IDAP REPORT

Property:	11 Merley Road, STRATHFIELD Lot 16 in DP 19348 DA2021.163
Proposal:	Alterations and additions to an existing dwelling
Applicant:	CplusC Architectural Workshop
Owner:	Peter Hoang
Date of lodgement:	2 July 2021
Notification period:	13 - 27 July 2021
Submissions received:	1 (one submission)
Assessment officer:	E Black
Estimated cost of works:	\$1,602,984.00
Zoning:	R2-Low Density Residential - SLEP 2012
Heritage:	Not a heritage item Not within a heritage conservation area Adjoins heritage item – I179 In the vicinity of heritage item – I178
Flood affected:	No
Is a Clause 4.6 Variation Proposed:	No
RECOMMENDATION OF OFFICER:	APPROVAL

Image 20: Window views from 13 Merely Rd, based on survey information

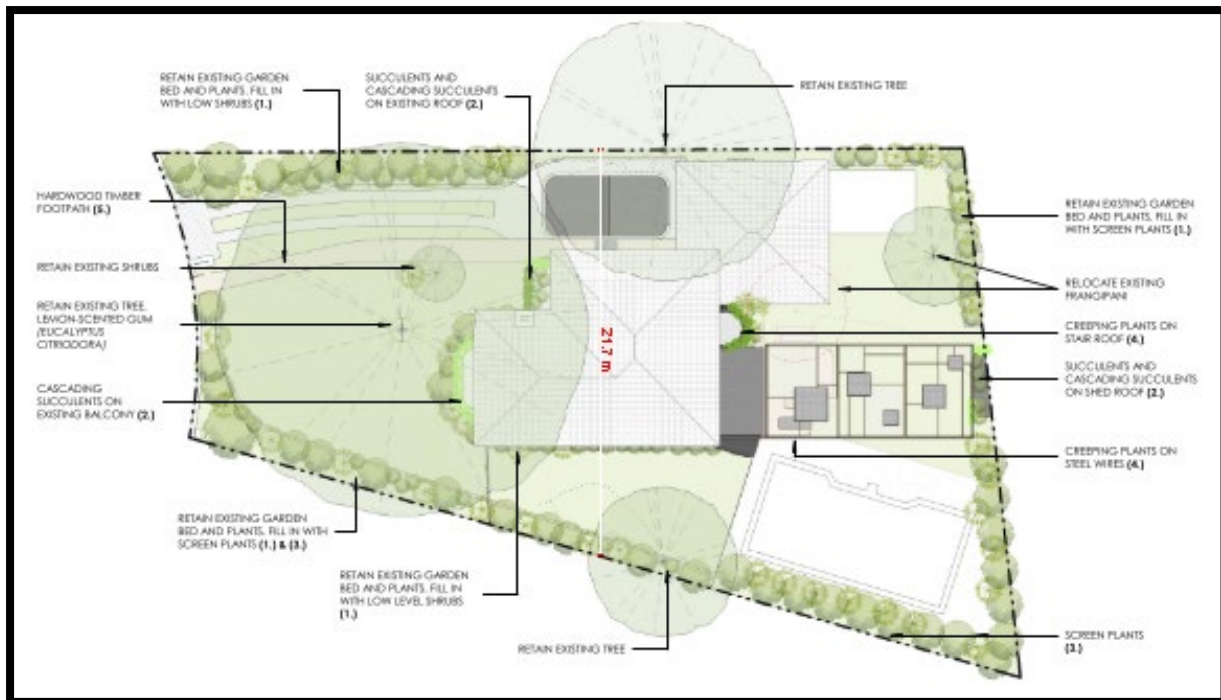
3. *The proposed extension results in the two sites ‘turning in on each other’ and will block views from the patio at No. 13 to the south east/Inveresk Park.*

Comment: The current dwellings at 11 and 13 Merley Road, as well as the proposed addition, are predominantly oriented to the street frontage. Diagrams submitted based off the survey (see Image 20), show that most windows will not be affected.

Image 22: Part of the shadow diagrams requested as further information.

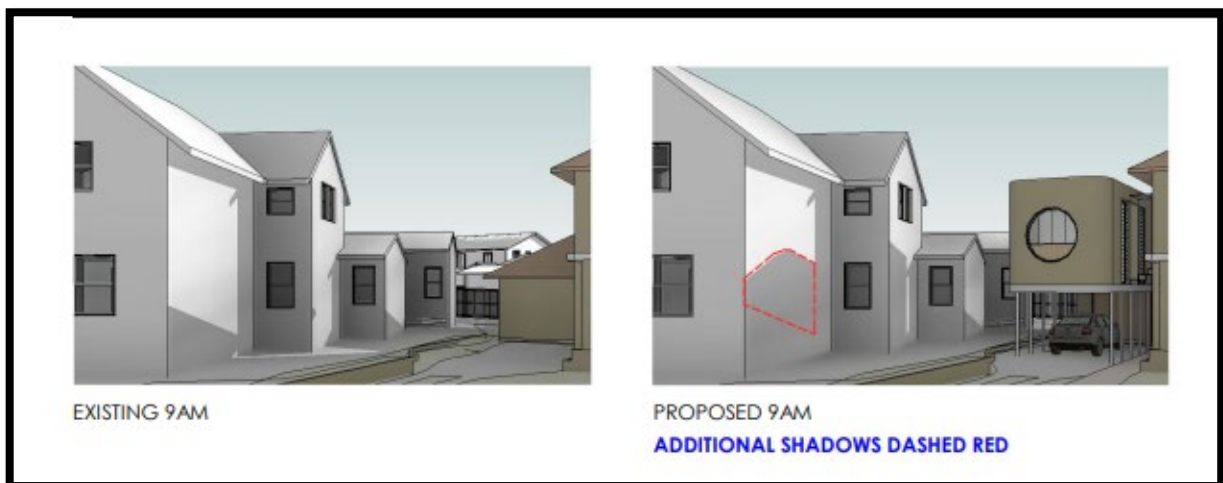
5. *Overshadowing of No. 13 has not been adequately considered, especially in regard to the positioning of windows along the western façade of 13 Merley.*

Comment: Additional information provided shows elevation shadow diagrams submitted as part of this response (see image 22). These demonstrate no additional overshadowing of windows along the western façade of 13 Merley Road during winter solstice. The pod will sit below the existing building height within the existing shadow.
